### **1. Barber Subdivision; KPB File 2023-013**

**ITEM 1 - BARBER SUBDIVISION**

<b>KPB File No.</b>	2023-013
<b>Plat Committee Meeting:</b>	February 27, 2023
<b>Applicant / Owner:</b>	Matt Barber of Hickman, Nebraska
<b>Surveyor:</b>	Jason Schollenberg / Peninsula Surveying, LLC
<b>General Location:</b>	Strawberry Road, Ridgeway

**STAFF REPORT**

PLAT OF  
**BARBER SUBDIVISION**

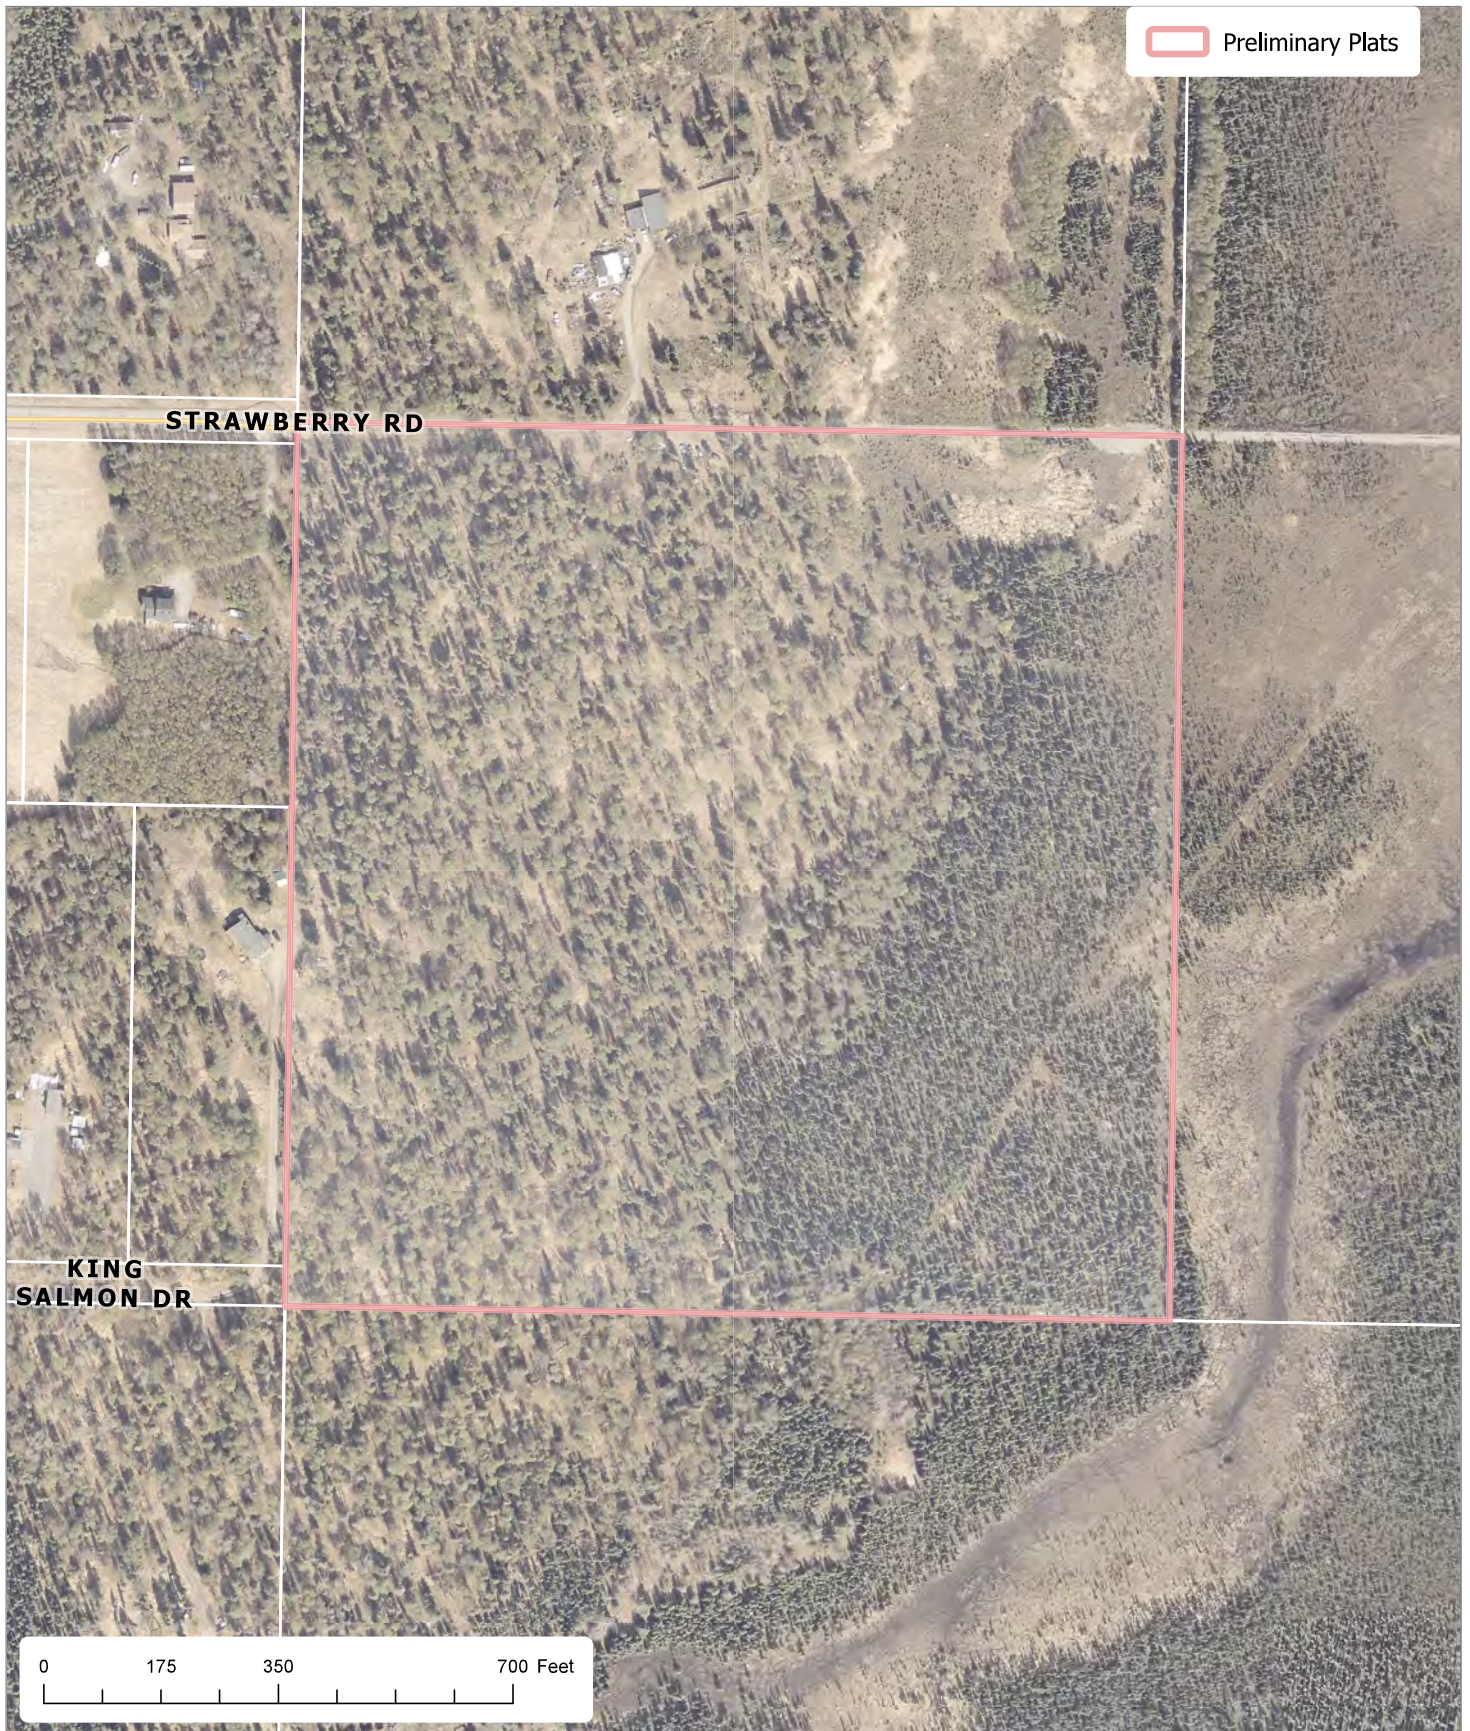
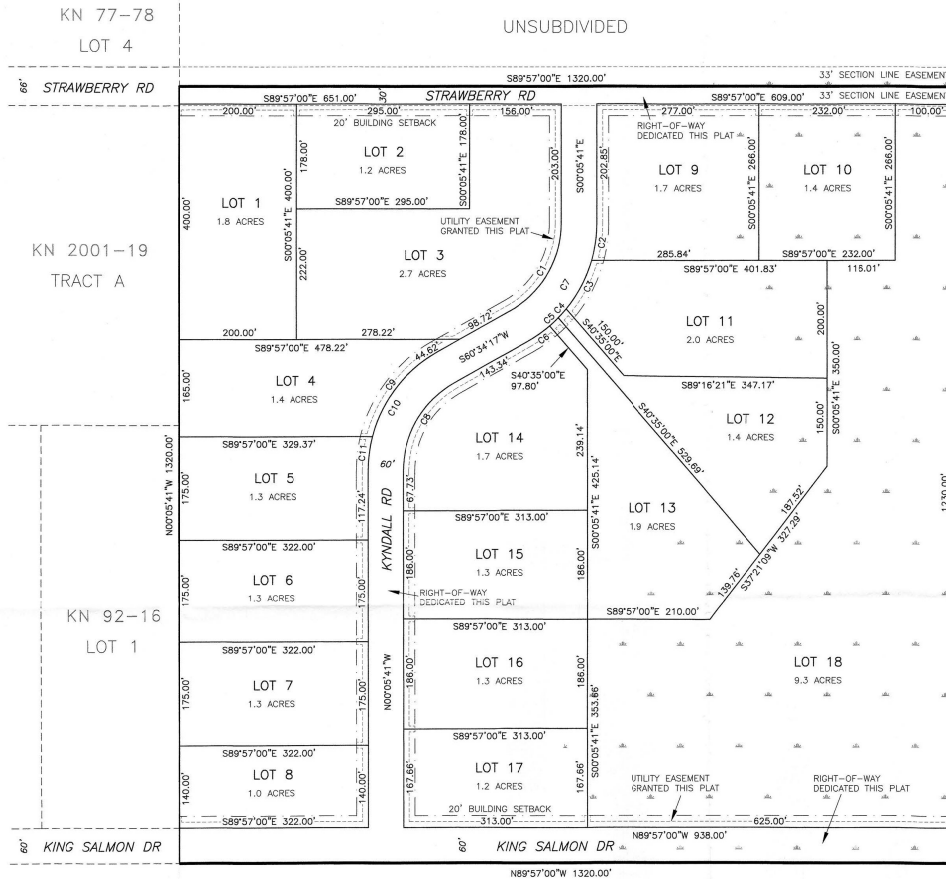
This plat is proposing to dedicate a 30 foot width for Strawberry Road atop an existing 33 foot section line easement. It appears to be cleared and used for access for the lot to the north as well as a large acreage lot to the east with improvements present. The northern portion of Strawberry Road appears to be subject to a 33 foot section line easement to provide additional width. If the owner to the north ever subdivides a matching dedication can be obtained. The western portion of Strawberry Road appears to contain some steep slopes. ***Staff recommends proof that the slopes comply with code or submittal of centerline profiles and cross-sections be submitted for review to determine if additional width or easements are required.***

Section line easements are along the northern boundary. **Staff recommends adjacent section line easements should be shown if right-of-way dedications have not been granted.**

**Site Investigation:** The property contains some low wet area within the eastern portion. **Staff recommends the wetlands remain on the final plat along with the determination note.**

Steep areas appear to be present within the proposed Strawberry Road dedication. The recommendation regarding the dedication is made within that portion of the staff report. The steep areas do appear to continue down into proposed Lots 1 through 4. **Staff recommends the slopes be verified and if any exceed 20 percent that the steep areas be depicted in some manner as it may impact development on lots of this size.**

An easement granted by recorded document was granted to Homer Electric Association, Inc. in 1959. Per the Certificate to Plat, the easement was released in 1997. It appears within the release that HEA reserved a 20 foot wide electrical distribution line easement centered on existing powerlines. **Staff recommends the surveyor work with HEA to determine the possible location of the reserved easement to depict, if the location cannot be found as the original easement had no defined location, then add plat notes with the original document information and the remaining easement.**

- Staff recommendation:** *A new unique subdivision name will be required as there is a Barber Tract Subdivision, KN 83-272.*
- C. The location, width, and name of existing or platted streets and public ways, railroad rights-of-way, and other important features such as section lines or political subdivisions or municipal corporation boundaries abutting the subdivision;

**Staff recommendation:** *Provide section line easement designations to the east of the subdivision. The City of Kenai limits are located along the western boundary. Provide a depiction and label.*

**Staff recommendation:** *Provide a Township label.*
- L. Contours at suitable intervals when any roads are to be dedicated unless the planning director or commission finds evidence that road grades will not exceed 6 percent on arterial streets, and 10 percent on other streets;

**Staff recommendation:** *The western portion of Strawberry Road dedication appears to have some slopes near 11 percent.*

- M. Approximate locations of slopes over 20 percent in grade and if contours are shown, the areas of the contours that exceed 20 percent grade shall be clearly labeled as such;  
**Staff recommendation:** *There appears to be some areas with slopes greater than 20 percent within lots within the northwest portion.*

**Staff recommendation:** *Provide documentation that the slopes comply with code or provide centerline profiles and cross-sections for Strawberry Road for review to determine if additional right-of-way width or easements are required.*

**Staff recommendation:** *Add the plat note: No structures are permitted within the panhandle portion of the flag lots.*
